Rattle Or Buzzing Noise At 1500 To 2200 Rpm**MODEL**

F30 (3 Series Sedan)	340i, 340i xDrive	With the B58 engine
----------------------	-------------------	---------------------

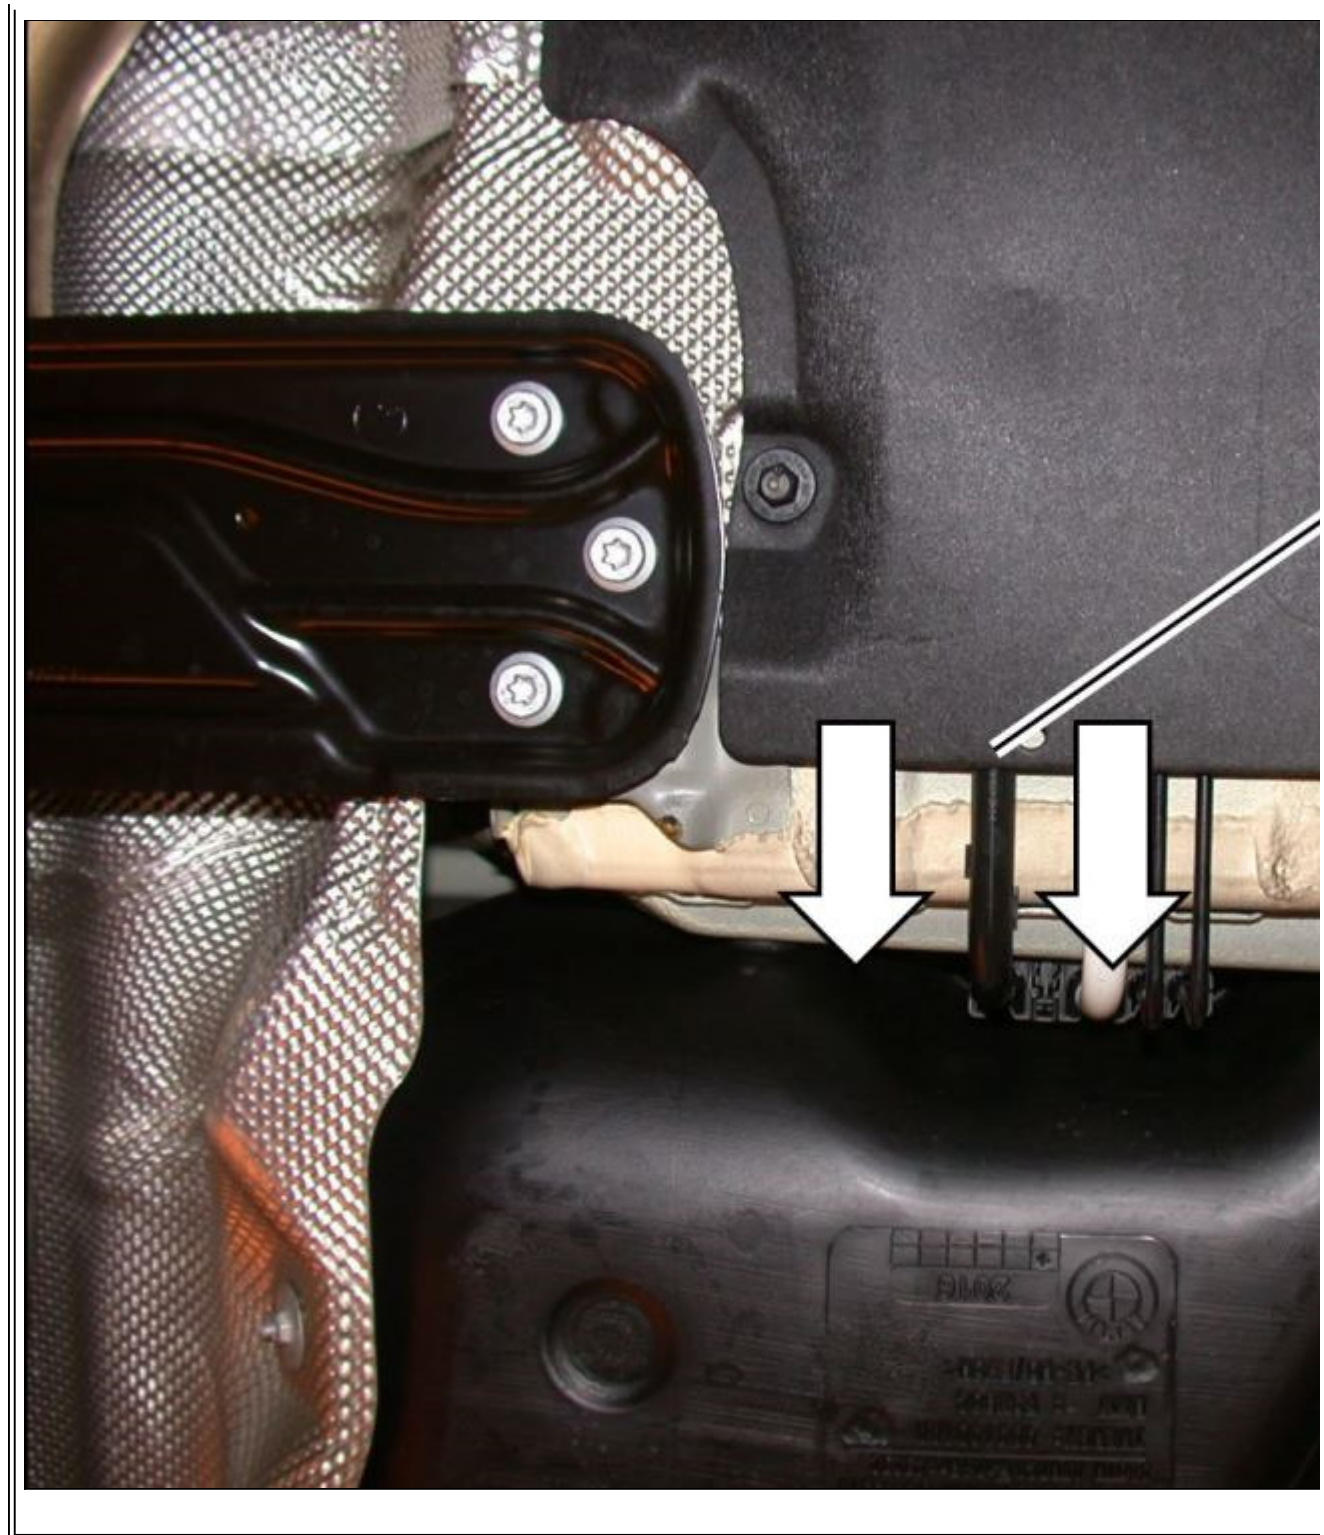
When accelerating, particularly when driving off on a slope, there is a buzzing, rattling noise coming from the driver's side underbody, near the footwell area.

The quick-release coupling for the fuel line is contacting the fuel line protective plate.

Insulate the low pressure fuel line at the fuel line protective plate.
